## NOTICE OF DECISION

## DECISION OF THE PLANNING ADMINISTRATOR

**TENTATIVE PARTITION PLAN / CLASS 2 ADJUSTMENT CASE NO.: PAR-ADJ24-11**

| <b>2886 BROOKS AVE NE</b>              | ) | <b>October 7, 2024</b>    |

# PROPOSED LAND PARTITION (OPTION 2)

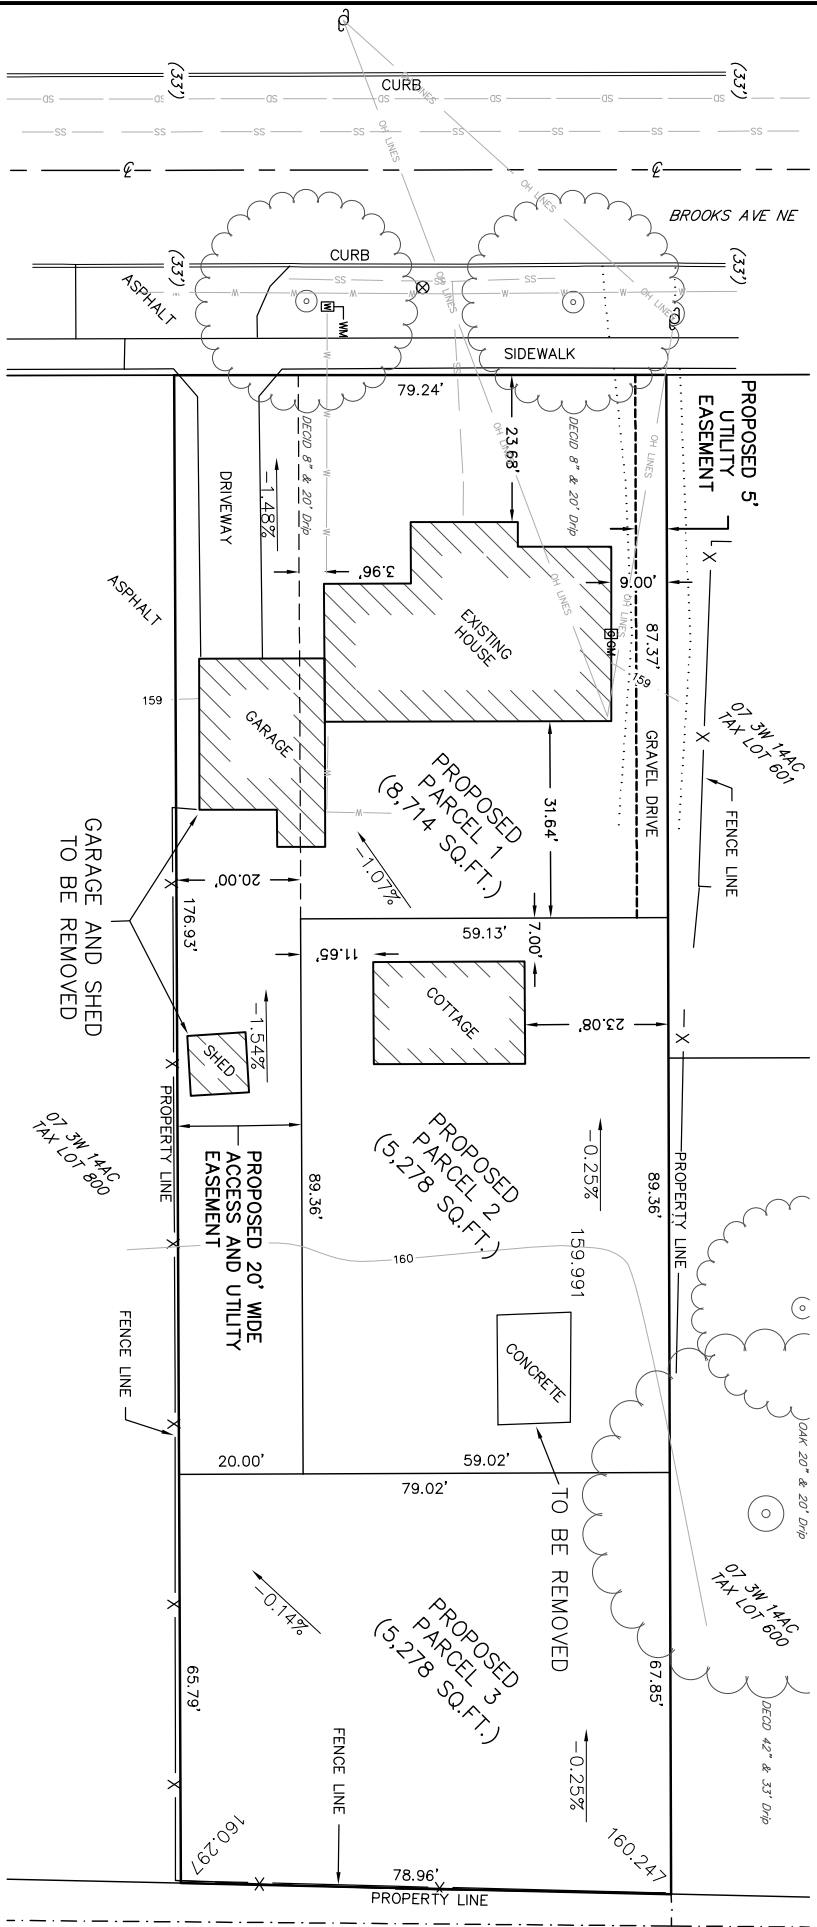
**Finding:** As shown on the tentative partition plan (**Attachment B**), proposed Parcel 1 is 5,168 square feet, exclusive of the accessway, and would have 59 feet of frontage on Brooks Ave NE. The proposed parcel is 59 feet in width, exclusive of the accessway, and 87 feet in depth. Parcel 1 meets the area, width, depth, and frontage lot standards. Proposed Parcel 2 will be an infill flag lot 5,278 square feet in size with 59 feet of width and 89 feet of depth and will have access to Brooks Ave NE via the flag lot accessway. Proposed Parcel 3 will be an infill flag lot 5,278 square feet in size with 59 feet of width and 89 feet of depth and will have access to Brooks Ave NE via the flag lot accessway. Proposed Parcels 2 and 3 do not meet the minimum 5,500 square foot area required of an infill flag lot. To ensure the parcels meet the minimum area, the following condition shall apply.

The plans also indicate there is an existing “cottage” on proposed Parcel 2, which is classified as an accessory structure. By definition, an accessory use cannot be permitted without a primary use on the property; therefore, in order to create the parcel, the accessory structure shall be removed or obtain the necessary permits to convert it to a standalone dwelling on the new parcel. To ensure the proposed partition plan meets the development standards of the RS zone, the following condition shall apply.

**Finding:** The tentative plan indicates the proposed flag lot accessway will be 177 feet in length by 20 feet in width, which, per Table 800-1, could serve a maximum of two dwelling units. With the existing dwelling on proposed Parcel 1, the flag lot accessway will serve three parcels and up to four units. The proposed accessway length is more than the maximum 150 feet length allowed and less than the minimum 25 feet in width to serve three to four units between the three parcels. Due to the location of the existing house and the infeasibility of providing a wider and longer accessway, the applicant has requested a Class 2 Adjustment to this standard, addressed in Section 9 below. To ensure the flag lot accessway can serve the three parcels and up to three-to-four units, the following condition shall apply.

**Finding:** Public water, sanitary sewer, and stormwater infrastructure is available along the perimeter of the site and appears to be adequate to serve the property as shown on the applicant’s preliminary utility plan. As specified in the conditions of approval, private water, sewer, and storm services shall be constructed to serve each lot as a condition of plat approval. This shall include the requirement to provide individual services for the single-family dwelling that is planned to remain on proposed Parcel 2 (labeled as “cottage” on the plans). All public and private City infrastructure proposed to be located in the public right-of-way shall be constructed or secured prior to final plat approval except as authorized in an improvement agreement per SRC 205.035(c)(7)(B). In order to ensure the parcels are served by public utilities, the following conditions apply.

**Finding:** The subject property is currently served by two 10-foot-wide driveway approaches onto Brooks Avenue NE, one along the northern property boundary and one along the southern property boundary. The driveway approach along the northern property boundary does not serve an approved off-street parking or vehicle storage area, pursuant to SRC 806.025. Pursuant to SRC 804.030(b)(1) driveway approaches onto local and collector streets shall only provide access to a permitted parking or vehicular use area. In addition, SRC 804.050(b)(1) Table 804-1 requires a minimum 10-foot-wide width for driveway approaches. As a condition of approval, the applicant shall close the driveway approach along the northern property boundary and replace with curbs, a landscape strip, and sidewalk.

The applicant's plan indicates the attached garage of the existing dwelling of Parcel 1 will be removed to accommodate the flag lot accessway. With the removal of the garage, the plans indicate the existing house will have a minimum setback of four feet from the proposed 20-foot-wide accessway. Due to the existing house and required setback, the accessway cannot be further widened without further alterations to the house. As proposed, the 20-foot accessway could only serve two units, limiting its access for proposed Parcels 2 and 3 only. Given the length of the existing lot at 242 feet, an accessway with a minimum 20-foot width and maximum 150-foot length would only allow for one exceptionally large lot in the rear of the property.

**Condition 1:** Prior to final plat, the applicant shall revise the proposed partition plan to ensure proposed Parcel 2 and Parcel 3 meet the minimum lot standards of SRC 511.010, Table 511-2.

**Condition 2:** Prior to final plat approval, obtain a demolition permit to remove the existing garage on the south side of the existing residence on Parcel 1, as well as the accessory structure within the proposed flag lot accessway. A minimum three-foot setback to the proposed flag lot accessway is required for any part of the existing dwelling on the parcel.

**Condition 3:** Prior to final plat approval, obtain a demolition permit to remove the existing accessory structure on proposed Parcel 2 or obtain the required building permits to establish it as a standalone dwelling.

- **Condition 4:** Prior to final plat, if the accessory building on Parcel 2 is to remain, the applicant shall revise the proposed plat to ensure the building meet the minimum setback standards of SRC 511.010, Table 511-3.

**Condition 14:** Prior to final plat or delayed pursuant to improvement agreement per SRC 205.035(c)(7)(B), the applicant shall permanently close the driveway approach along the northern property boundary and replace with curbs, a landscape strip, and sidewalks.
